AMENDMENT DRAWING

AMENDMENT DRAWING

Project Title: VA PUGET SOUND HEALTH CARE SYSTEM UPGRADE SEATTLE ELECTRICAL DISTRIBUTION FROM 5kV TO 15kV

Drawing Number: 100-EP602T1R

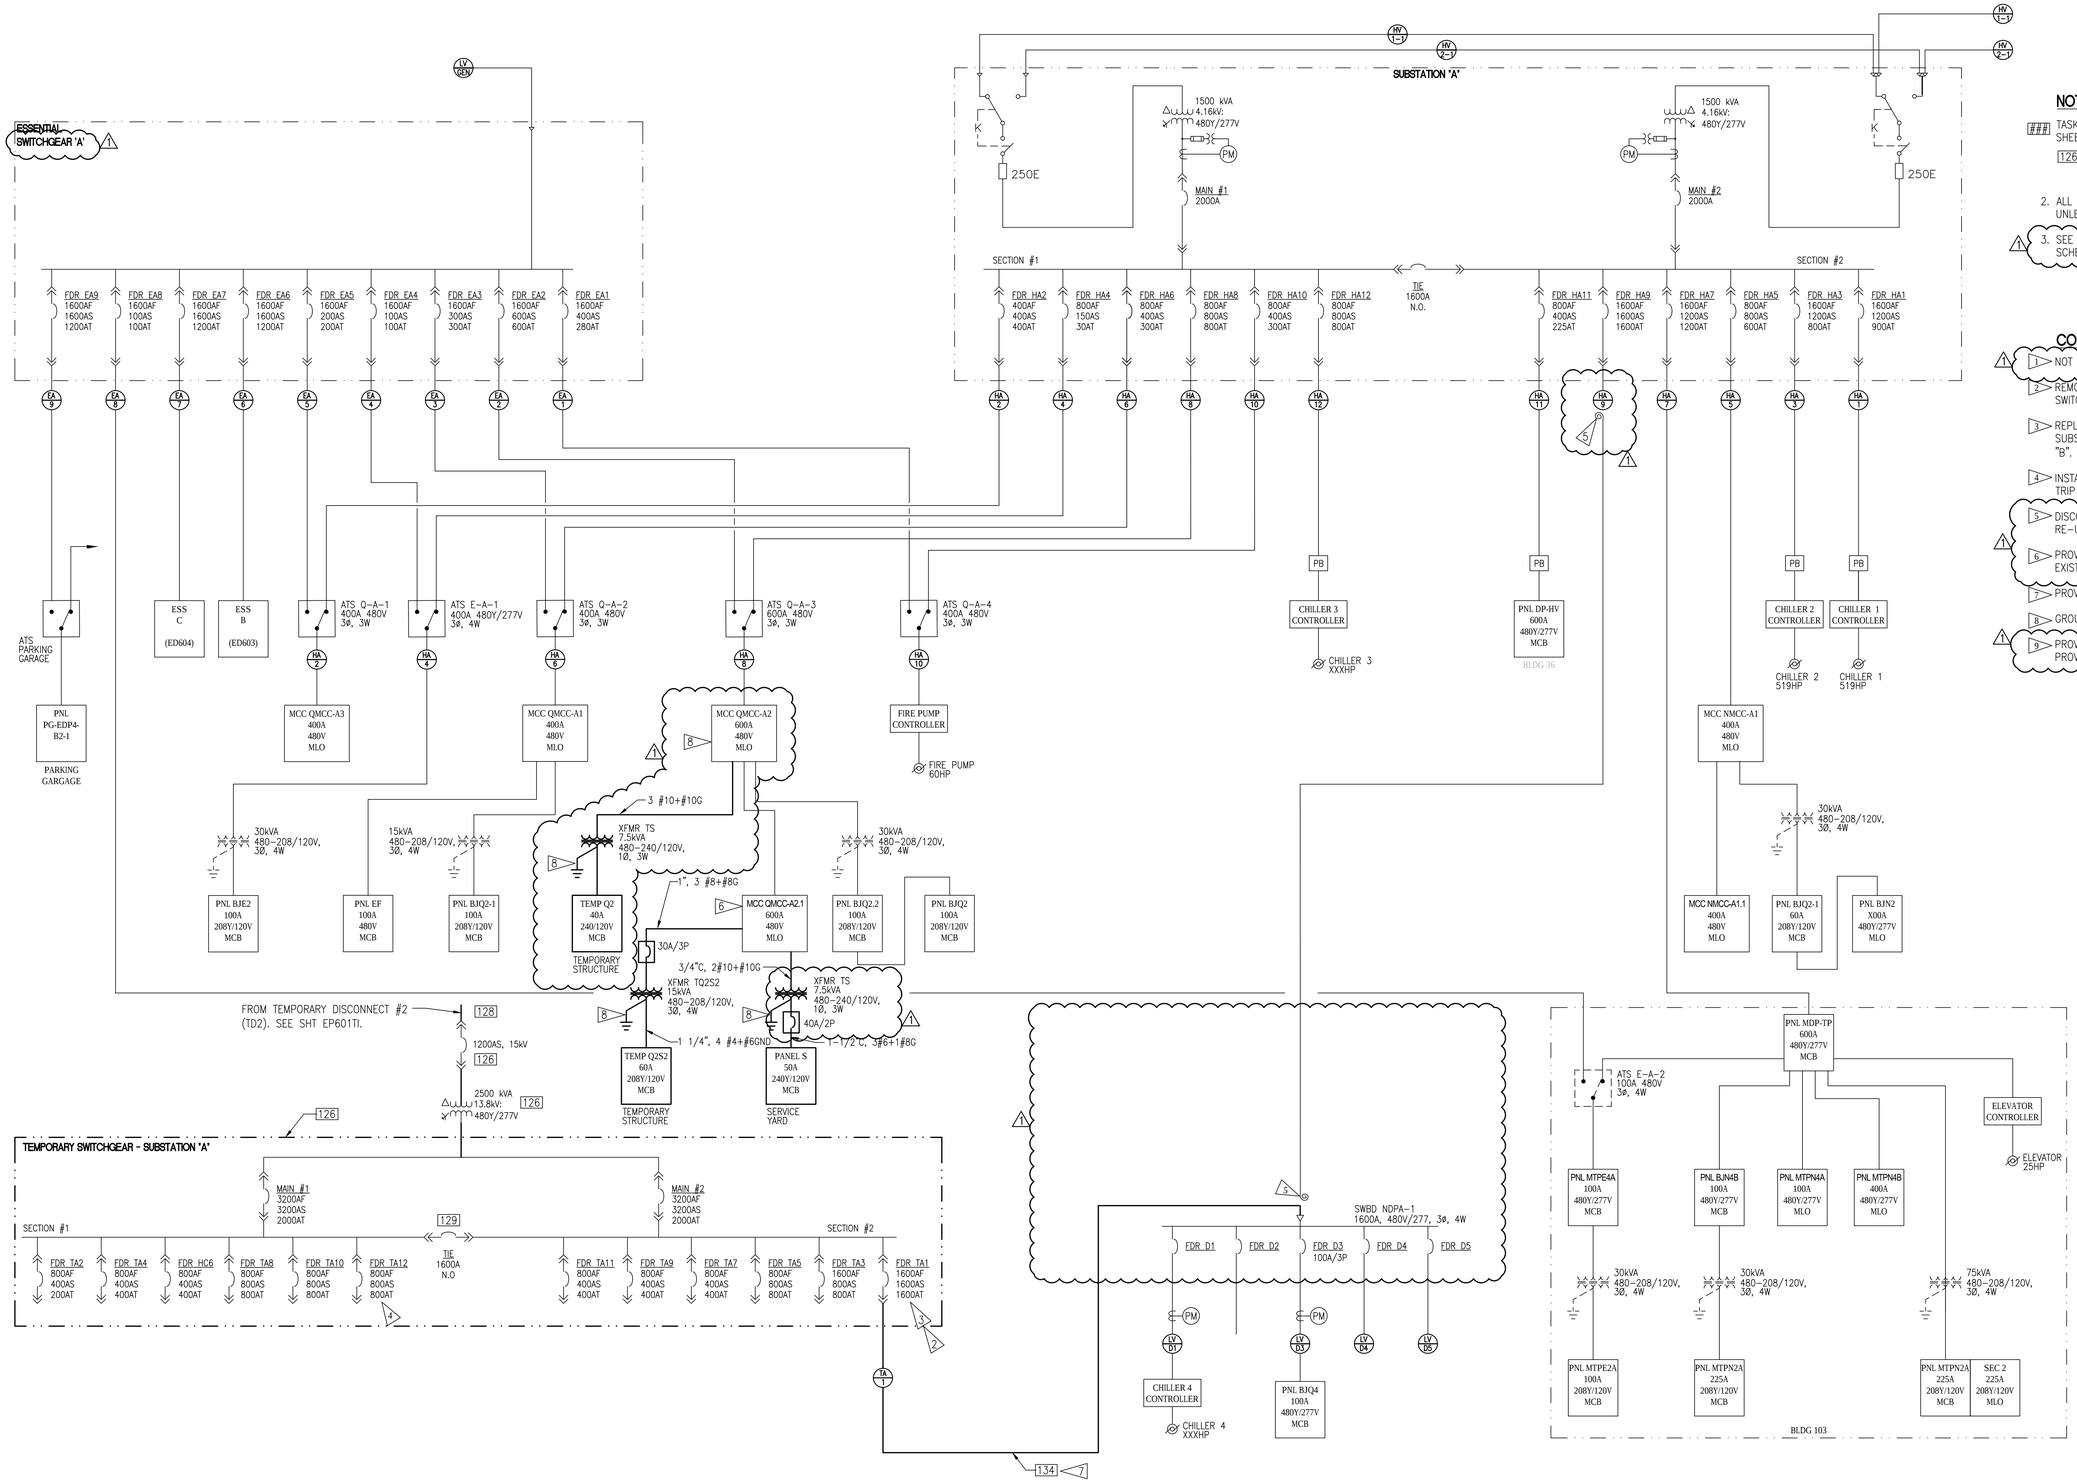
1. NOT USED.
2. REMOVE SENSOR AND PLUG TRIP UNIT AND INSTALL IN SWITCH POSITION HC12.
3. REPLACE SENSOR MODULE WITH EXISTING FROM SUBSTATION "B". PROVIDE PLUG TRIP UNIT RATING SIZE AS SHOWN.
4. INSTALL PREVIOUSLY REMOVE 800A SENSOR AND PLUG TRIP SEE CONSTRUCTION NOTE 1.
5. DISCONNECT EXISTING CONDUCTORS AND COIL FOR RE-USE.
6. PROVIDE 30A-3P AND 20A-2P CIRCUIT BREAKERS IN EXISTING MCC. PROVIDE COVER WITH OPERATING HANDLES.
7. PROVIDE FEEDER PER SHEET ES800 OR ES801.
8. GROUND PER NFPA 70, ART. 250.
9. PROVIDE 20A-2P CIRCUIT BREAKERS IN EXISTING MCC. PROVIDE COVER WITH OPERATING HANDLE.

Drawing Number: 100-EP602T2R

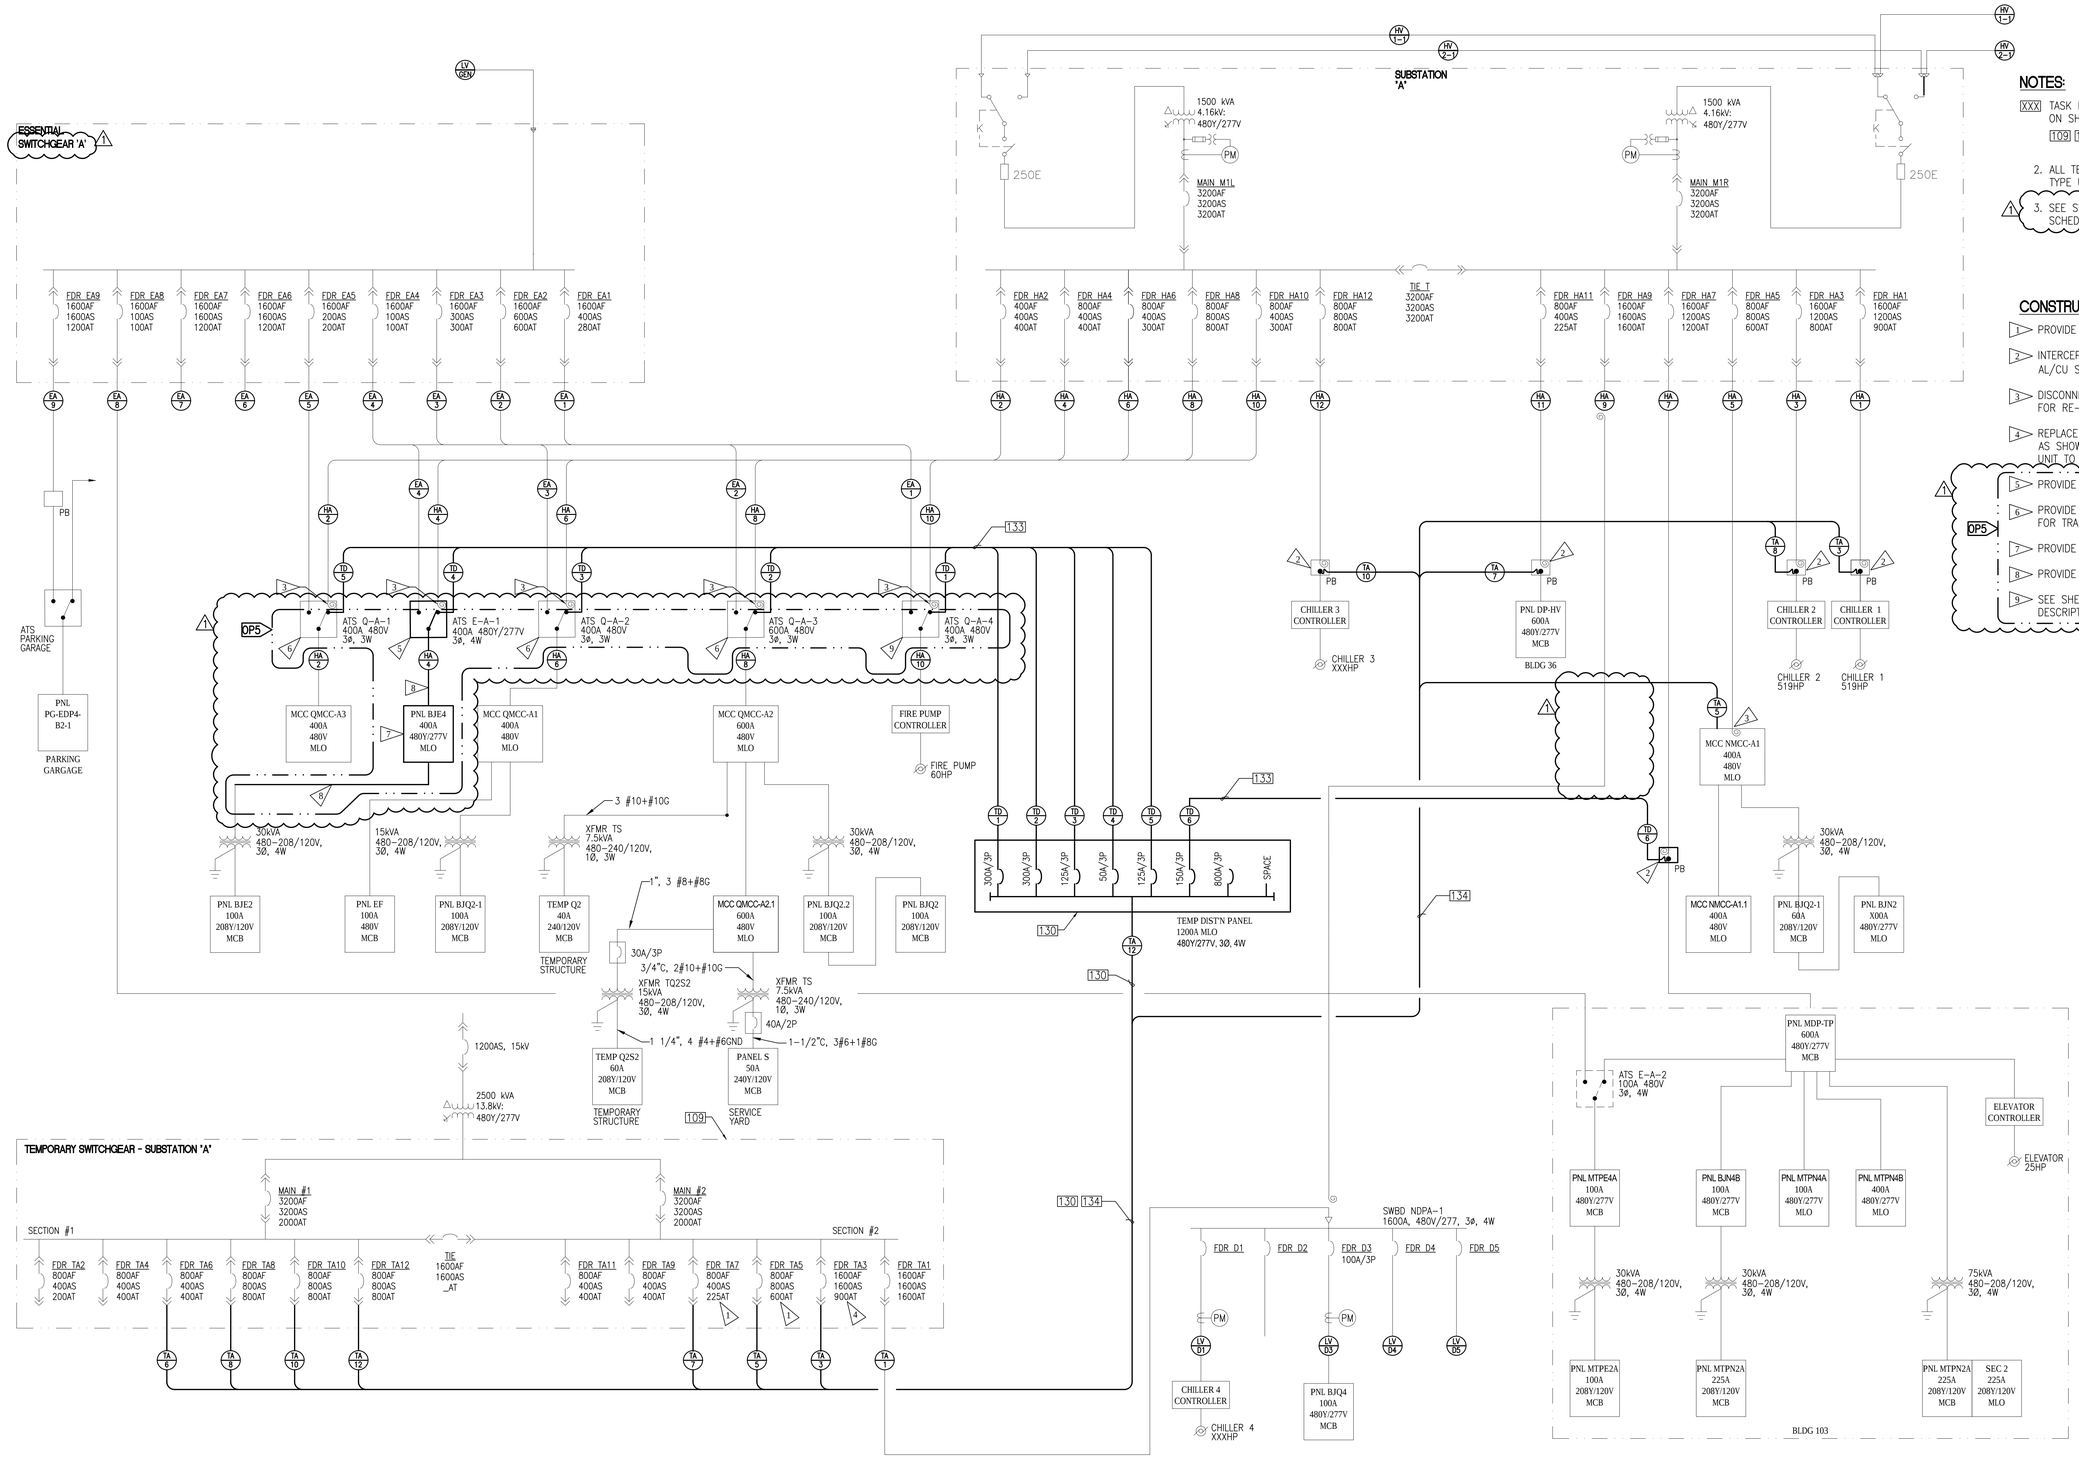
1 PROVIDE PLUG TRIP UNIT RATING SIZE AS SHOWN.

2 INTERCEPT EXISTING FEEDER. PROVIDE DUAL RATED, AL/CU SPLICE KIT.

3 DISCONNECT EXISTING FEEDER CONDUCTORS. MAKE SAFE FOR RE-USE.

4 REPLACE SENSOR AND PLUG TRIP UNIT WITH NEW SIZE AS SHOWN. RETURN REMOVED SENSOR AND PLUG TRIP UNIT TO VA.

1 OP5
5 PROVIDE NEW BYPASS ISOLATION TRANSFER SWITCH.
6 PROVIDE NEW INTERIOR ASSEMBLY AND FRONT COVER FOR TRANSFER SWITCH
7 PROVIDE NEW PANEL.
8 PROVIDE NEW FEEDER.
9 SEE SHEET 100-EP109T4 FOR ADDITIONAL WORK DESCRIPTION.

Drawing Number: 100-EP602T3R

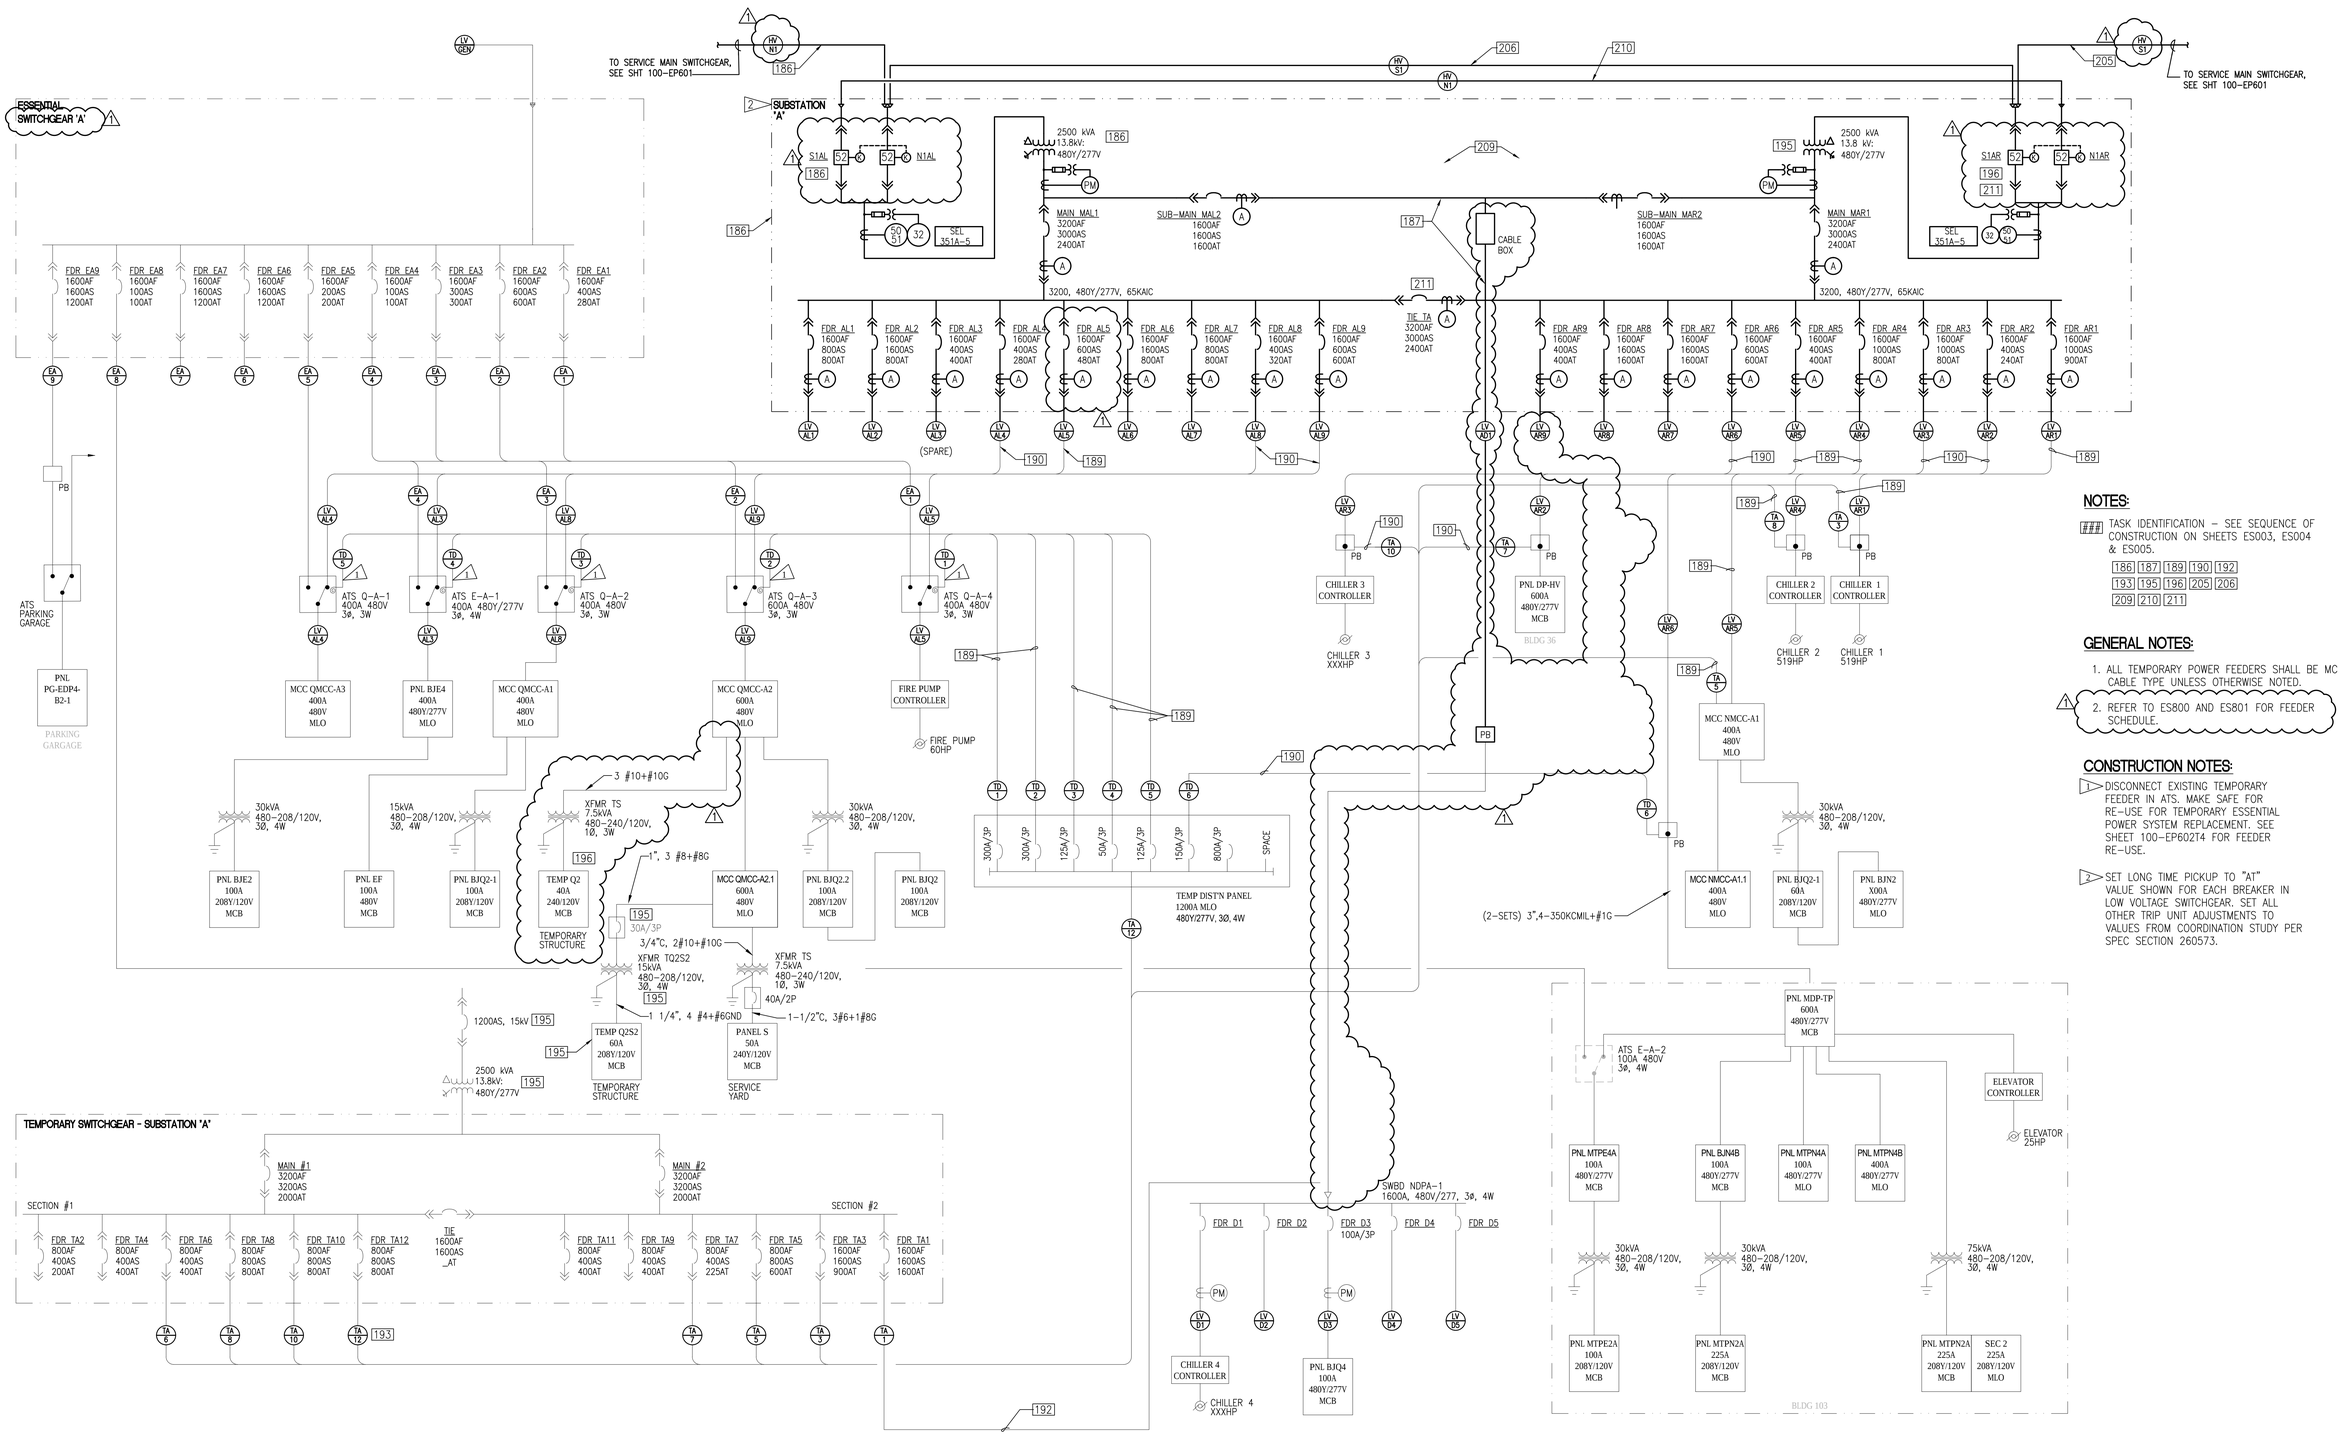
1. DISCONNECT EXISTING TEMPORARY FEEDER IN ATS. MAKE SAFE FOR RE-USE FOR TEMPORARY ESSENTIAL POWER SYSTEM REPLACEMENT. SEE SHEET 100-EP602T4 FOR FEEDER RE-USE.
2. SET LONG TIME PICKUP TO "AT" VALUE SHOWN FOR EACH BREAKER IN LOW VOLTAGE SWITCHGEAR. SET ALL OTHER TRIP UNIT ADJUSTMENTS TO VALUES FROM COORDINATION STUDY PER SPEC SECTION 260573.
